IN REPLY REFER TO: FID #241378280
Milwaukee Co.
ER/SFND

SUBJECT: Integrated Review of Soil and Groundwater Remedy Letter
Submittal, Moss-American (Kerr-McGee) Superfund Site,
Milwaukee, WI

Discussion Points
Moss-American Site
Re: Jan. 20, 1997 Submittal
Soil and Groundwater Remedy

Re: Moss-American Site, Milwaukee, Wisconsin
Integrated Review of Soil and Groundwater Remedy

FIGURE 1

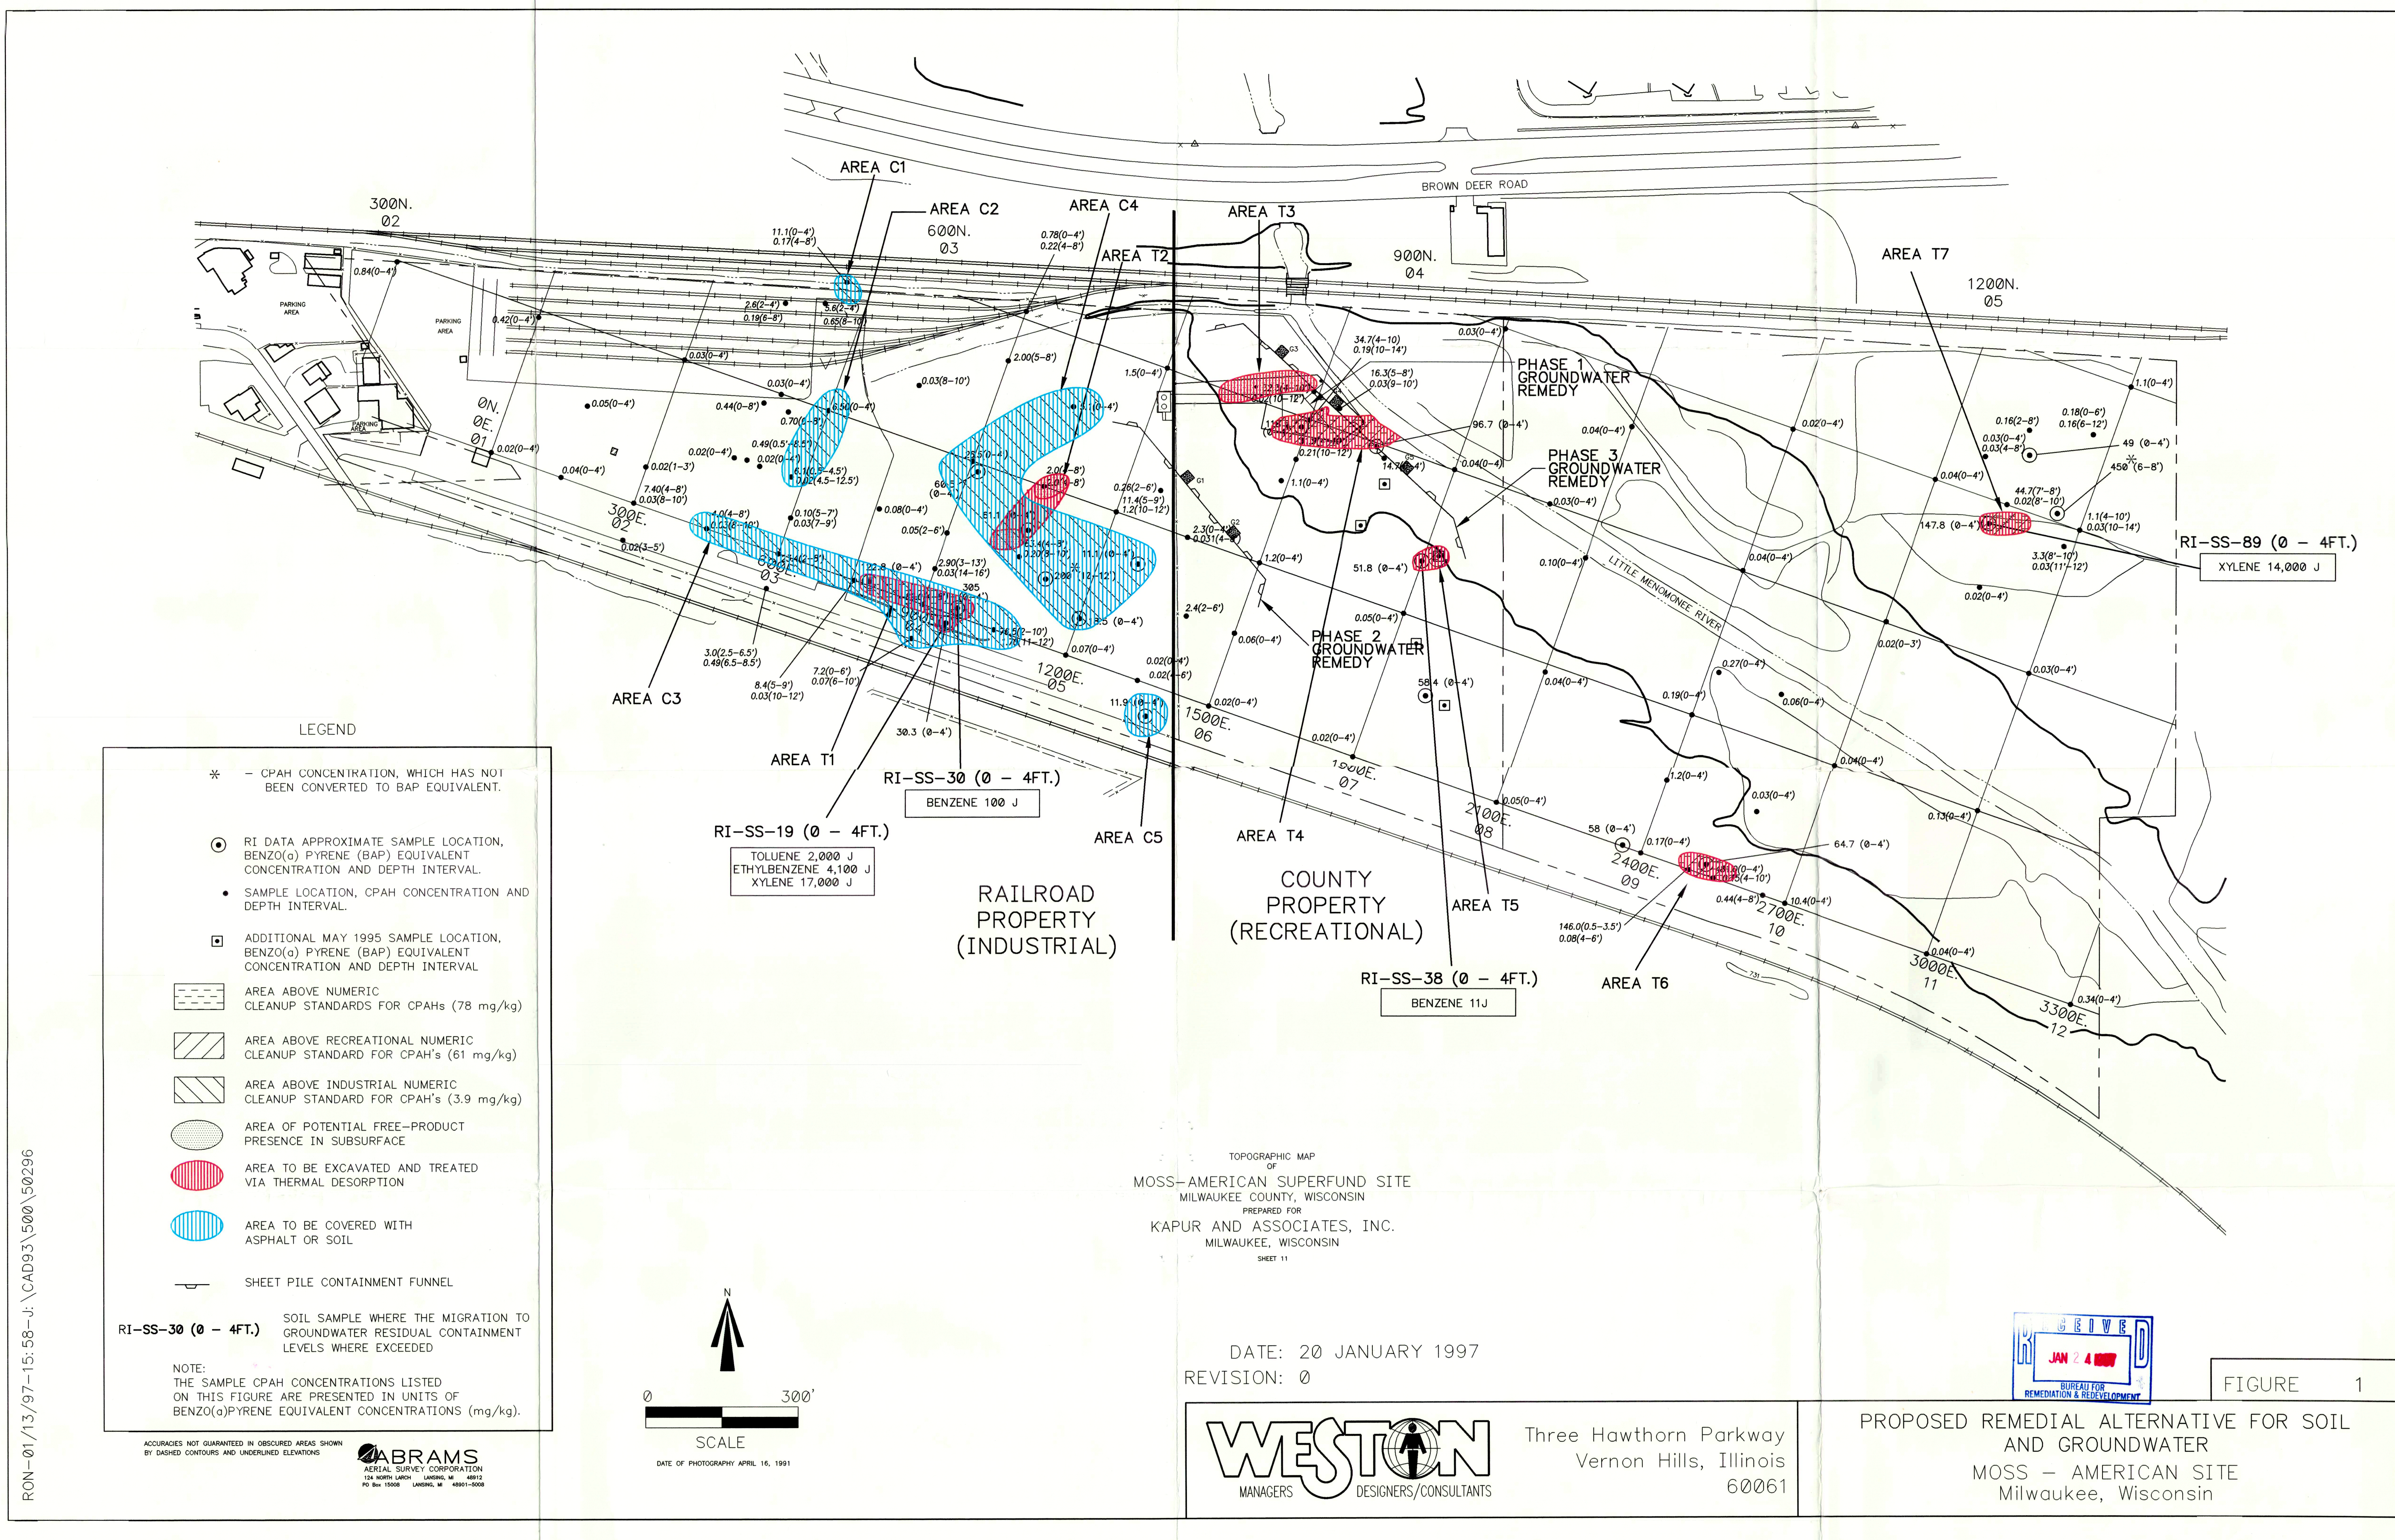
- a. It's not clear how the residual concentration levels (RCLs) for protection of the groundwater were determined. It is not clear which levels were used. Which compounds were used and at what concentrations? Was this based on the November 19, 1996 Weston submittal prepared for the November 21, 1996 meeting? That submittal was marked "preliminary, issued for discussion".
- b. We have not concurred with the 78 mg/kg soil standard for LTDD treatment, as outlined in previous correspondence.
- c. The areas and volumes of soil remediation should only be presented as very rough, initial estimates, requiring refinement through discrete sampling. The areas may change based on discrete confirmation sampling. As outlined in section F of our February 1, 1995 comments on the Predesign Submittals, the composite soil

sampling results should not be used to determine the exact areas requiring remediation, nor for exact volume calculations. Additional discrete sampling will be needed to determine the exact extent of the remediation.

- d. Thermal desorption effectiveness should be determined based on actual field pilot tests at this site. We are willing to consider variable redisposal unit design standards for thermally treated soil, based on actual field results, as alluded to in your January 27th telefax.

My observation is that this seems basically a sound approach, however NR 720.11(2)(b) should also be considered. This contains a footnote indicating that while PAHs are generally of concern only as a direct contact threat because of their relatively low migration potential, the specific PAH of naphthalene appears to be an exception.

FIGURE 2

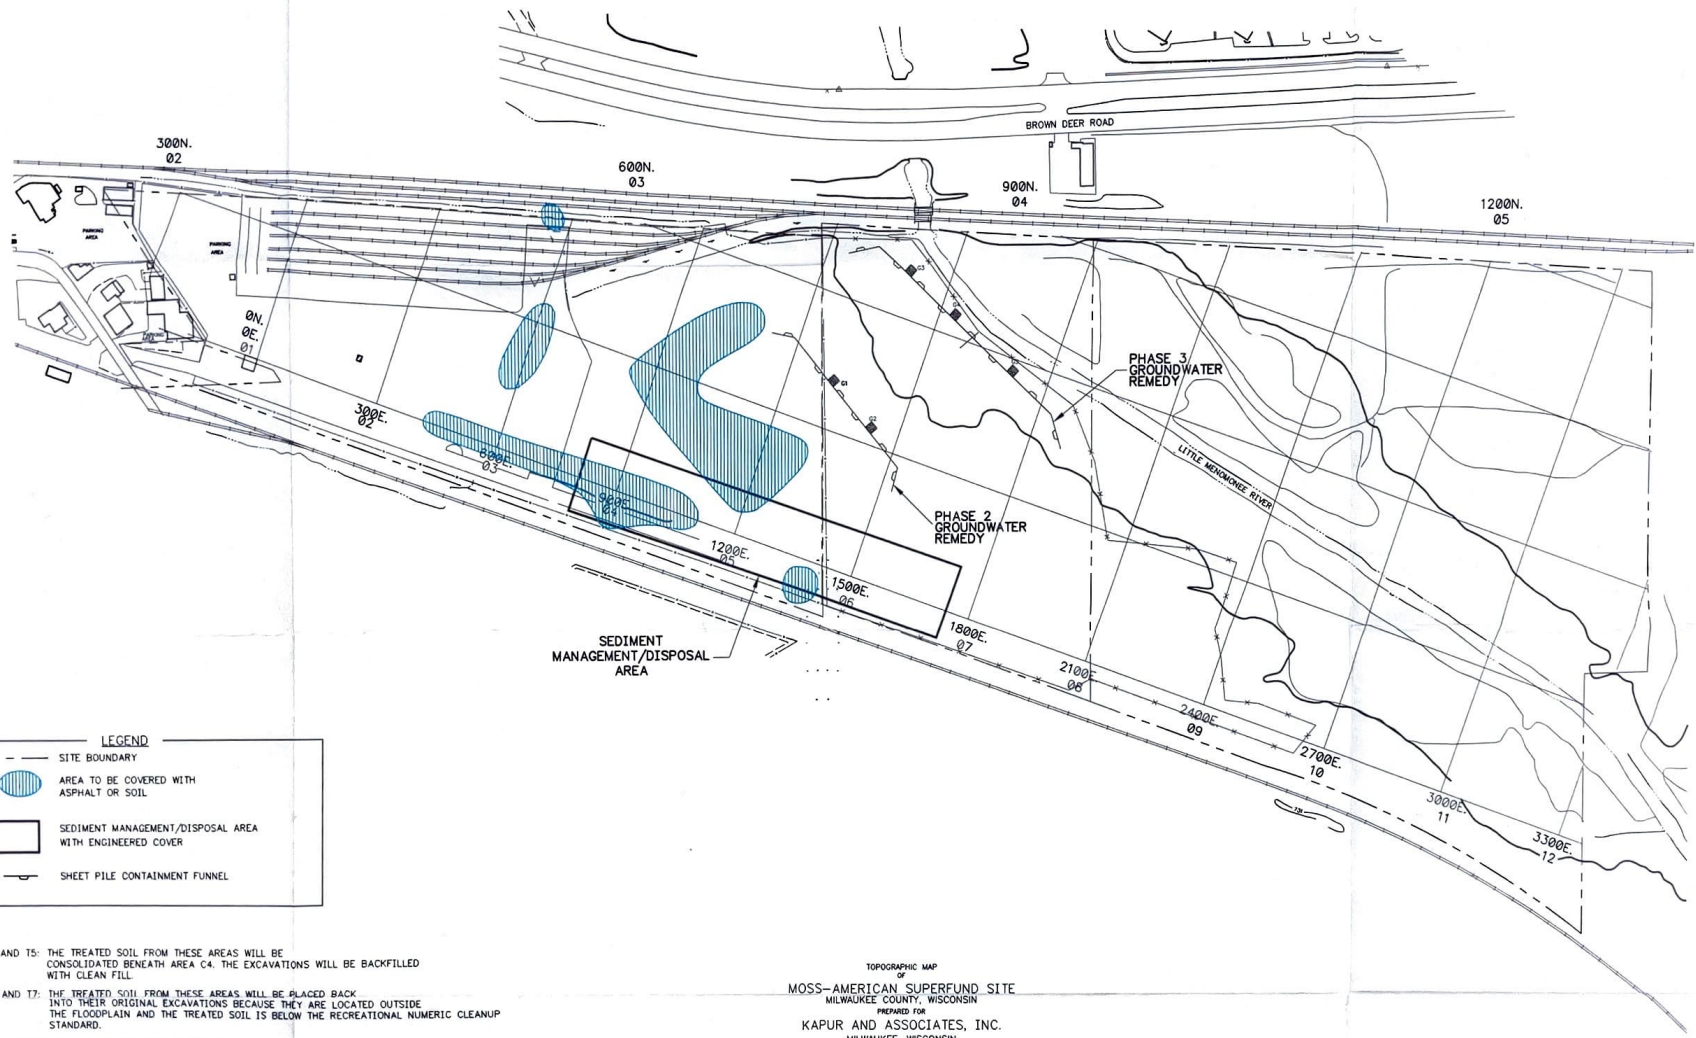
- a. We suggest that treated material be managed in one unit rather than spreading it around the site in various areas that may need remediation using a cover. It should be managed in an area that is as great a separation to groundwater as possible. As stated above, we are willing to discuss variable unit (liner, if necessary and cover) designs based on actual LTTD effectiveness determined in the field.
- b. We have outlined our concerns about the aggregate/asphalt and 6" soil cover proposals in point A.5. of our December 6, 1996 letter to you. Those concerns have not been addressed yet.

- c. The minimum design we may be willing to accept for an untreated sediment redispasal unit is outlined in the first point #2 of our letter to you of January 15, 1997. We believe in place recompaction of clay for a liner and 12" of clay and 6" of topsoil for a cover are not considered acceptable engineering designs for this purpose, as they will not provide reliable containment over time. For example, simply recompacting the clay in place does not account for clay quality variability, and will likely have areas that will leak leachate. No leachate collection is proposed. A 12" clay cover is subject to drying, frost and rooting damage.

Treated Soil Management/Untreated Surface Soil - Some combination of either 6" of soil and vegetative cover (or, on railroad property possibly asphalt cover) is proposed after treatment. If indeed the "Average B-A-P" soil concentrations after treatment as listed in Jan. 20 submittal Table 2 are attained in the field, then there may be merit for less rigorous covering than the 2' soil cover as envisioned by the ROD. For recreational usage, where per 10/18/95 WDNR calculation 49 mg/kg B-A-P appeared to satisfy the exposure scenario, areas T4-T7 are well below this value. Area T1, on railroad property, is a borderline case regarding achievement of an industrial exposure scenario ranging from 3.9 to 6.2 mg/kg. Hence, greater protection provided by a cover for this area may be necessary. It occurs to the reviewer that flexibility may be needed in the field pending actual treatment results obtained before a commitment to a given cover dimension is made. If treatment results are well below contact threats for a given exposure scenario, then a less rigorous cover approach may be appropriate. If potential threat after treatment is above a value derived for a given scenario, then a default/conventional cover dimension may be justified. If the situation is borderline, then perhaps some hybrid thickness could be considered. Such reasoning might govern untreated areas as well.

Sediment Management - The submittal appears to use the reasoning that since sediments (on average?) for segments 1-4 are under 78 mg/kg B-A-P that no treatment of sediments is justified. The reviewer does not necessarily agree with the specific reason cited, but rather notes that a possible consideration for not treating sediments pertains more to the logistics of the situation where it may be somewhat difficult to segregate higher PAH/lower PAH sediment portions once remediation begins. (Note - for discussion purposes, do these sediments constitute "solid waste" excavated during a response action as envisioned by NR 718?) If not immediately, then after some dewatering or leachate collection step is performed? If so, then does NR 718.05, Storage of Contaminated Soil, become relevant for consideration?
